RS-15-129

Braidwood Station, Units 1 and 2
Facility Operating License Nos. NPF-72 and NPF-77
NRC Docket Nos. 50-373 and 50-374

Subject: Response to Request for Additional Information Regarding Request for a License Amendment to Braidwood Station, Units 1 and 2, Technical Specification 3.7.9, "Ultimate Heat Sink"

RATIO OF EFFECTIVE TO CROSS AREA FOR LAKES OF VARIOUS LENGTH TO WIDTH AND DEPTH TO WIDTH RATIOS
Figure MES-11.1-02

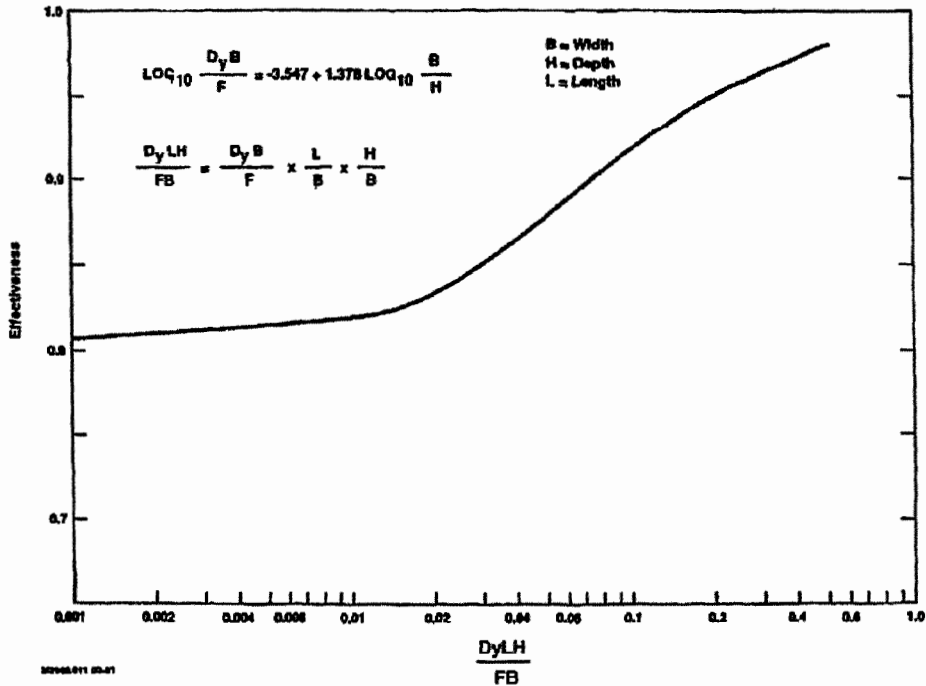
Provide justification that demonstrates that the LakeT-PC model accurately represents the effective essential cooling pond volume and surface area with sufficient accuracy and within the margin of error for the temperature of cooling water that supplies the safety related loads.

Effectiveness - Effective Area and Volume were calculated to be 82.3% of gross values. Effectiveness of the UHS was determined in Calculation MAD 83-0239. The methodology utilized for calculation of the Braidwood UHS effectiveness has subsequently been documented in S&L Engineering Guideline MES-11.1. The main inputs for lake effectiveness are the lake

size/shape and water flow. Based on figure MES-11.1-02, presented below and as included in a response to an NRC RAI received for the LaSalle UHS temperature increase request (Reference 9), the effectiveness of the main channel varies from approximately 81 to 98%. Therefore, the value of 82.3% calculated in MAD 83-0239 is conservatively on the lower side of the curve. Note that the Braidwood UHS is a man-made rectangular shape lake without any side arms or odd shapes.
